GEOTECHNICAL 3rd PARTY REVIEW OF
DEVELOPMENT ALTERNATIVES
PROPOSED WEST VILLAGE PROJECT
TENTATIVE TRACT 71546
CITY OF CALABASAS,
LOS ANGELES COUNTY, CALIFORNIA

March 5, 2020
(Revised March 31, 2020)

**Subject: Geotechnical 3rd Party Review of Development Alternatives
Proposed West Village Project, Tentative Tract 71546
City of Calabasas, Los Angeles County, California**

Figure 5 - Section 4 - 4' Preliminary Concept - Drilled Shaft Buttress System - Alternative 4

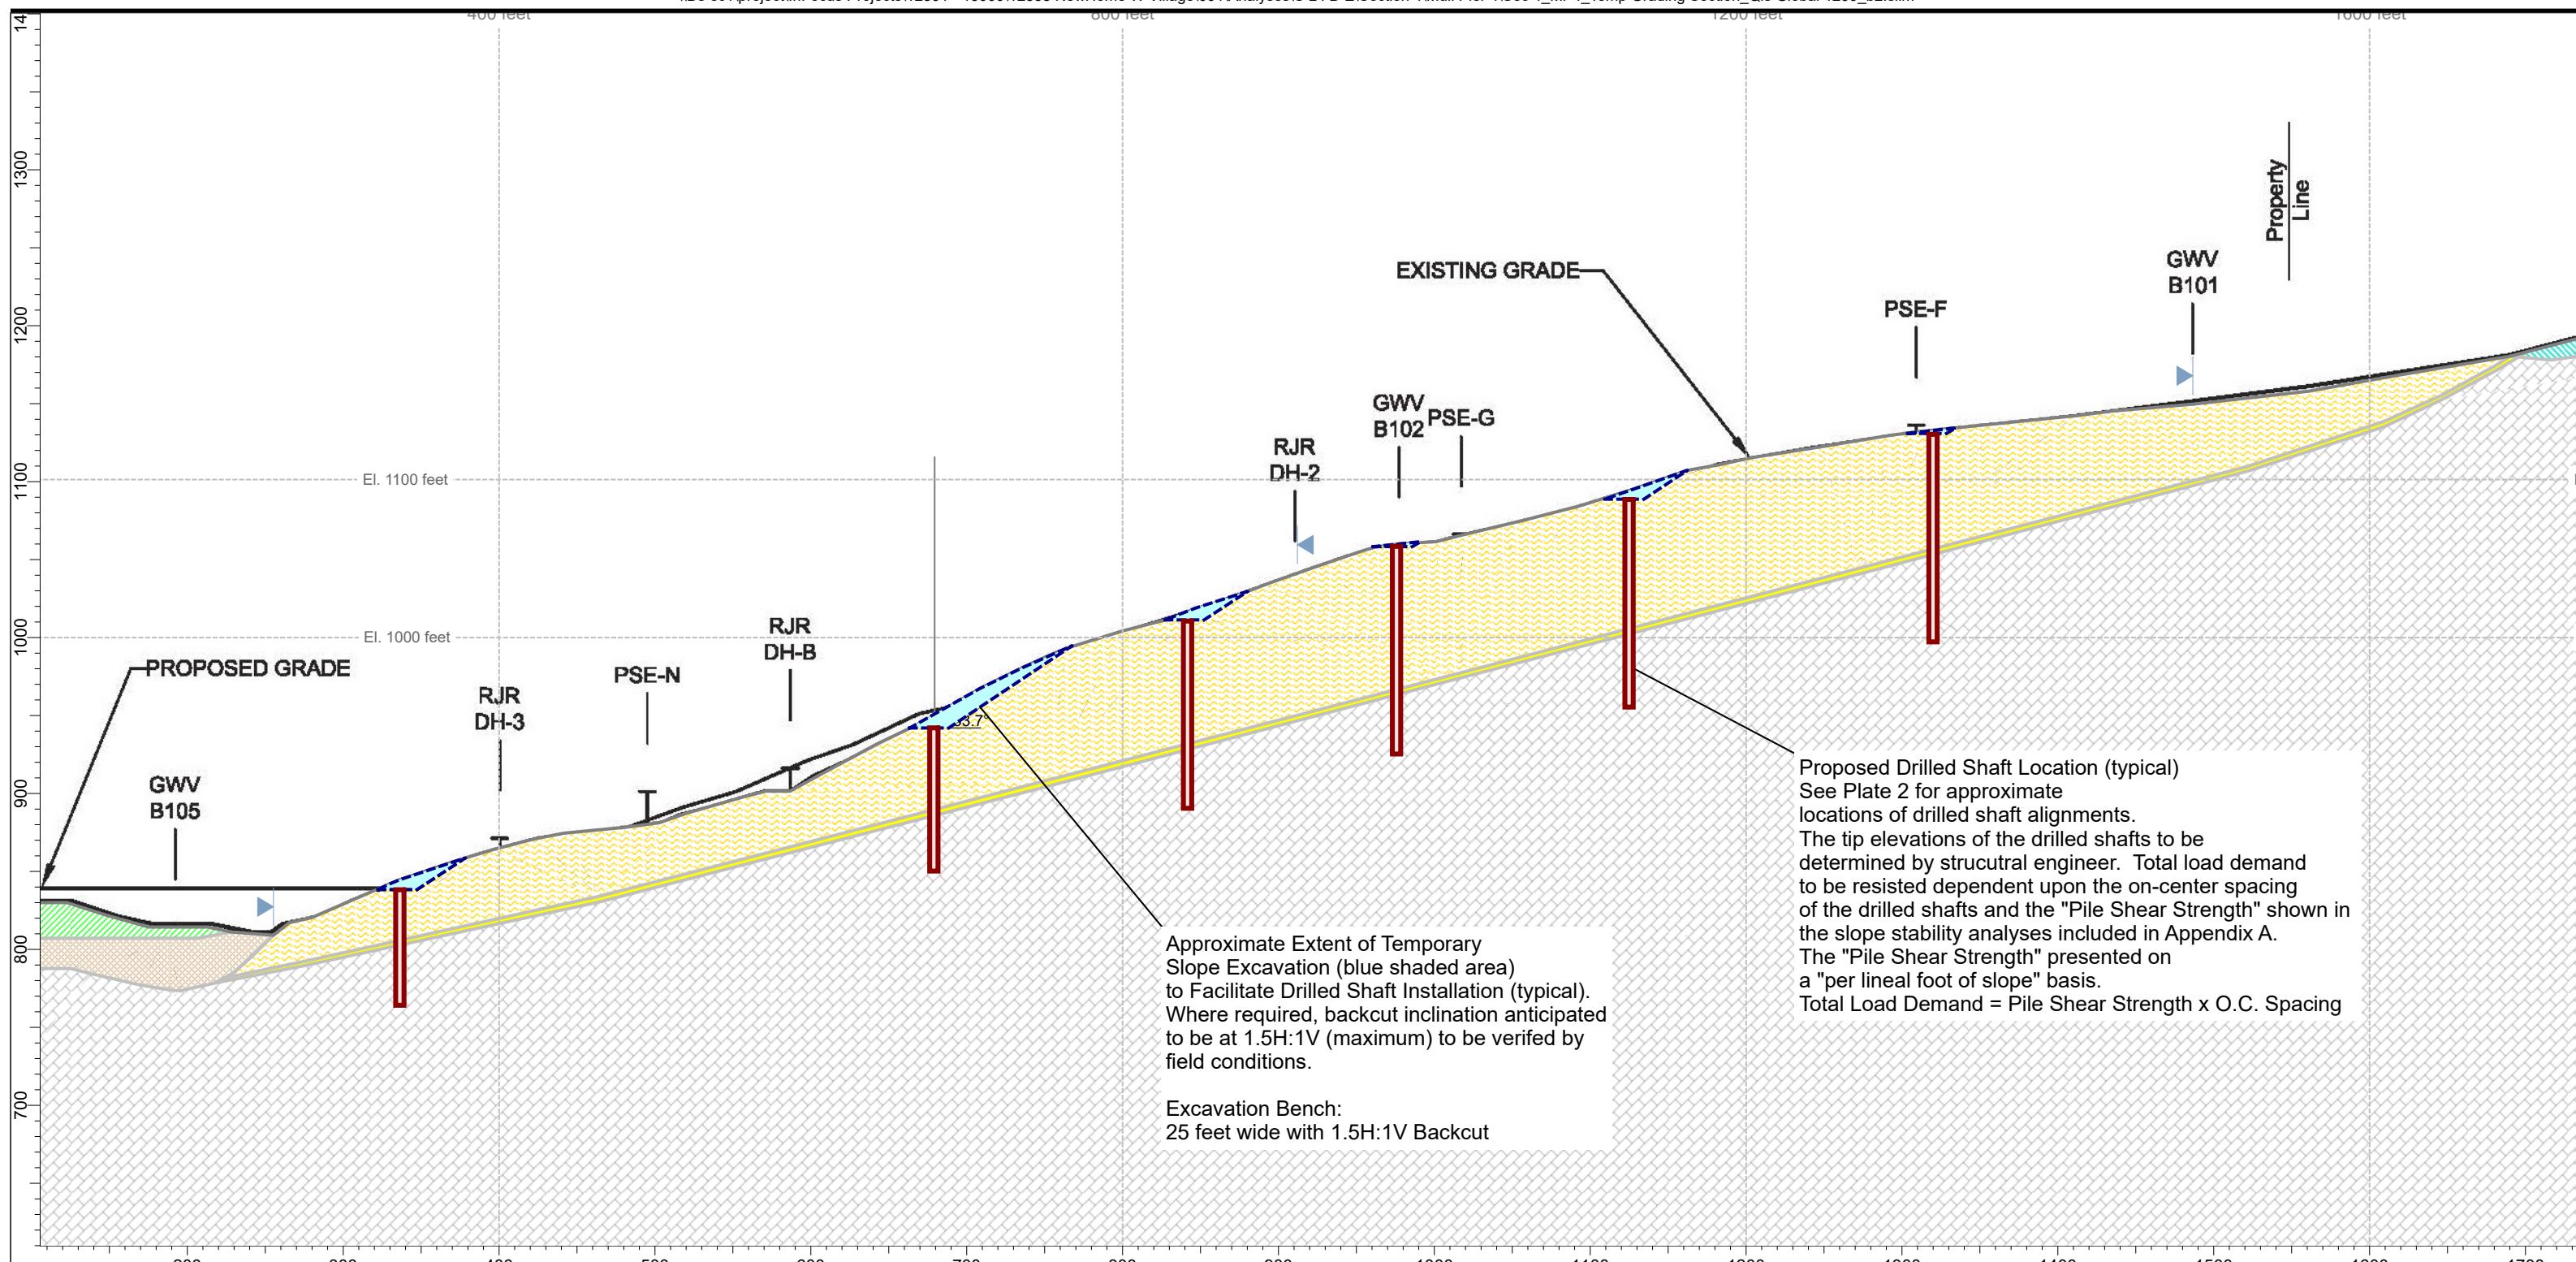
Slope stability analysis presented herein for Cross-Sections 3-3' and 4-4' (Appendix A) were performed to develop a preliminary design concept to stabilize the slope and mitigate the potential for a catastrophic event due to increase in pore pressures due to groundwater buildup and/or seismic conditions. Cross-sections 3-3' and 4-4' were selected for analysis to provide a preliminary assessment of the load demand imposed upon a drilled shaft buttress system since these sections were located in the central region of the slide where the depth to the slide mass and the load demand are greatest. The analyses indicate multiple rows of drilled shafts (see Plate 2) extending up the slope well beyond the limits of development will be necessary to develop a mechanical buttress system and achieve the minimum required factors of safety for gross stability and seismic stability of the site. This method of mitigation will not prevent surficial failures from occurring and impacting the site. The load demand combined with the number of reinforcing elements that will be necessary is expected to reduce the feasibility of this alternative. Although we cannot estimate the cost of such a design, our experience suggests this type of design would likely be deemed not financially viable and is not free of risk from surficial instability.

Figures 4 and 5 (and Plates 5 and 6) are based upon the geologic Cross-Sections 3-3' and 4-4'. As discussed previously for Alternative 1, these sections were selected for analysis since they represent the greatest depths to the slide plane and, as a result, the greatest load demand on the buttress system. These figures and plates show the locations in which drilled shafts will be required to achieve the desired calculated factors of safety. The approximate limits of temporary cuts (i.e., benching and backcuts) to facilitate construction of the drilled shaft buttress system are shown based upon the preliminary design developed for these cross-sections. These figures are intended to provide a conceptual view of the temporary earthwork that is likely to be necessary for drilled shaft construction.

Based on a review of the plans and on the interpreted geologic conditions, both the originally proposed Alternative 4 design and the subsequently proposed modification to Alternative 4 (i.e., the drilled shaft buttress system) are not favorable options because they do not mitigate all the potential landslide hazards that may impact the proposed development and do not provide the same level of assurance that neither the project site nor nearby development would be adversely impacted by the landslide hazard as the subject project and Alternatives 2, 3, and 5. Therefore, we do not recommend Alternative 4 for the subject site because the landslide hazard mitigation proposed for the subject project and Alternatives 2, 3 and 5 includes known, reliable mitigation options that are more comprehensive in their mitigation of the landslide hazard.

We conclude that Alternative 1 poses a low risk to adjacent improvements, though long-term maintenance would be necessary. For the original design of Alternative 4 and its modified design as presented by Leighton, we do not recommend reliance on a buffer zone coupled with the proposed drilled shaft buttress system due to the lack of sufficient data for each proposed elemental segment and in consideration of an unnecessarily high risk mitigation option so close to a known complex landslide hazard. The proposed system is uncommon and relatively untested and does not address all potential landslide conditions.

GEOTECHNICAL MAP - DEVELOPMENT ALTERNATIVE 5		Plate-1
Proposed "West Village" Residential Development Las Virgenes Road, Calabasas, California		
Proj: 12558.001	Eng/Geol: JEH/AAP	
Scale: 1"=100'	Date: March 2020

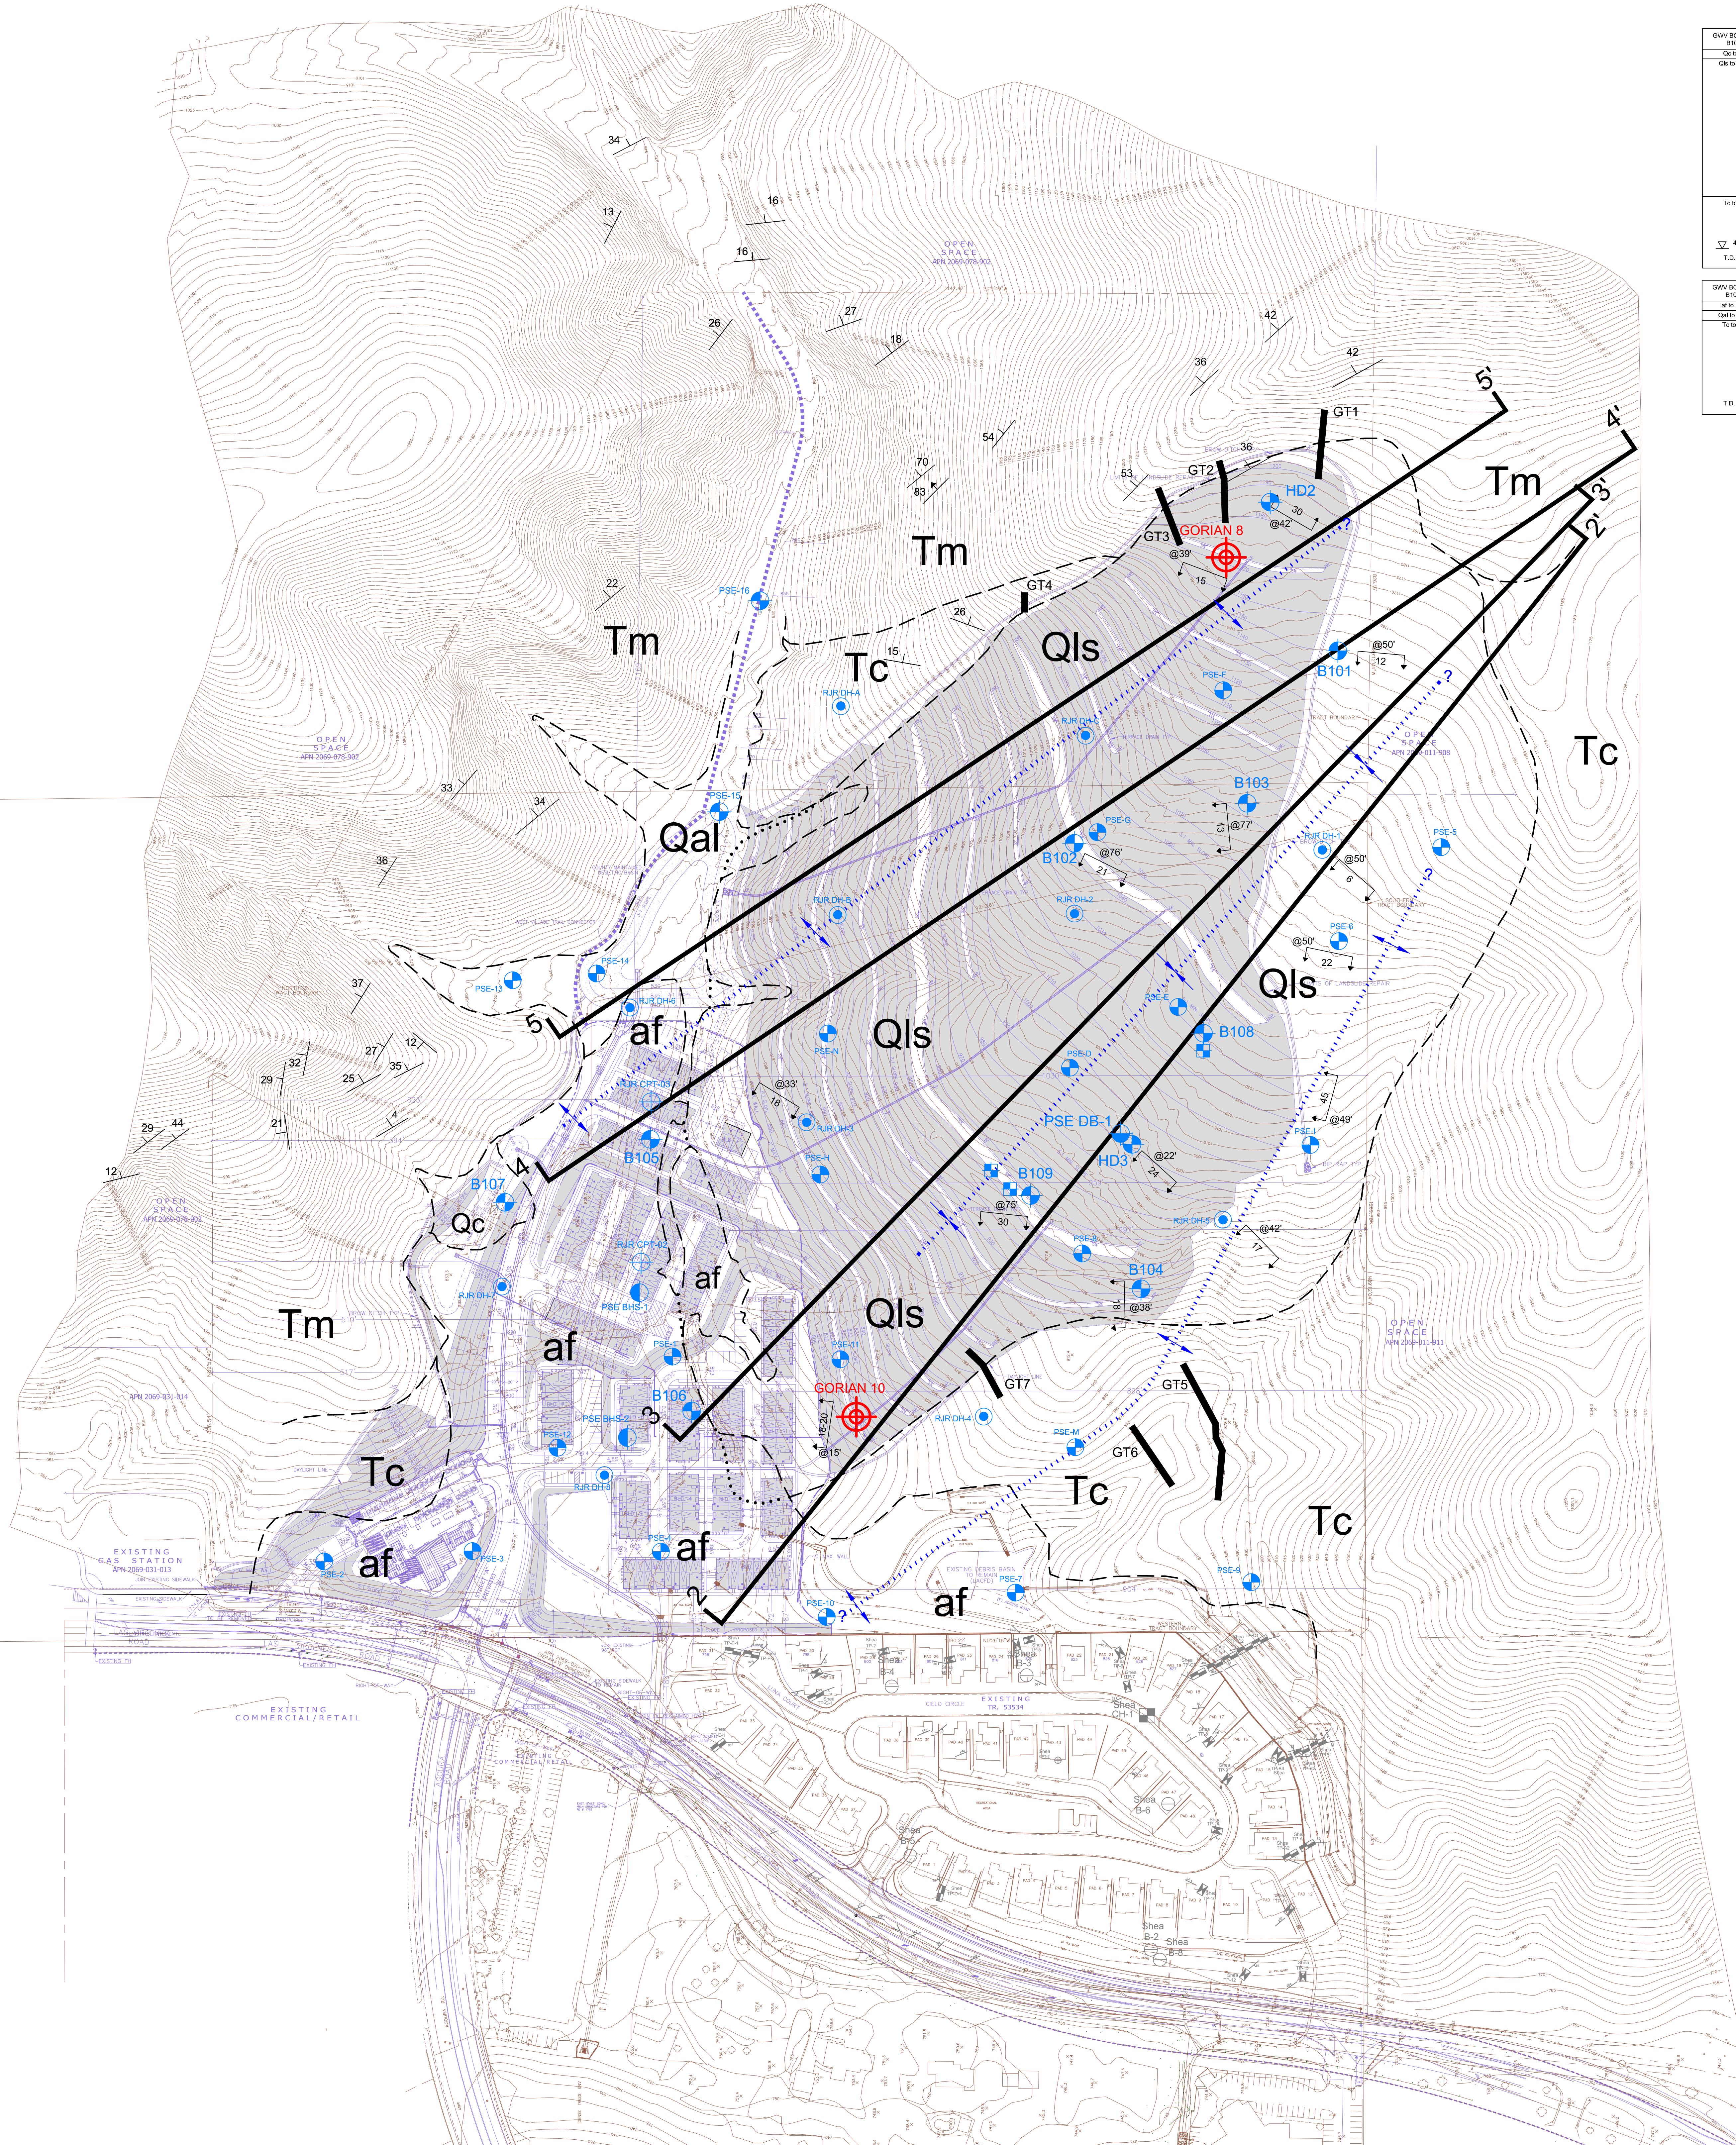
The development concept and associated site grading for Alternative 5 is shown Plate 1. The grading depicted on the preliminary grading plan for this alternate appears to be essentially the same as the grading planned for the "Proposed Project". Discussion present above in conjunction with this other development scenarios (except Alternative 4) is considered to be generally applicable to Alternative 5. Therefore, the proposed Alternative 5 is expected to be a feasible development concept with regard to geotechnical considerations provided site grading include remedial earthwork activities to properly buttress the landslide and improve stability.

From a geotechnical perspective, Alternative 5 and the previous grading plan (hereafter referred to as the 2017 Plan) are similar. The minor modifications to the grading plan do not warrant any new or revised geotechnical recommendations. Furthermore, our geotechnical review of the 2017 Plan (GWV, 2017) was approved by Wildan, the reviewer for the City of Calabasas, in their letter dated May 15, 2017. Accordingly, the existing body of geotechnical recommendations is considered applicable to and appropriate for Alternative 5. No new recommendations are presented and the grading plan for Alternative 5 is considered to be feasible from a geotechnical perspective.

The lower residential pad was raised approximately two feet from elevation 801 to 803. The middle residential pad was lowered approximately seven feet from elevation 825 to 818. The upper residential pad was lowered approximately one foot from elevation 839 to 838. Differences between plans along the cross section lines are insignificant; therefore, cross sections and slope stability analyses presented in our report addressing the 2017 Plan (GWV, 2017) may be considered representative of Alternative 5.
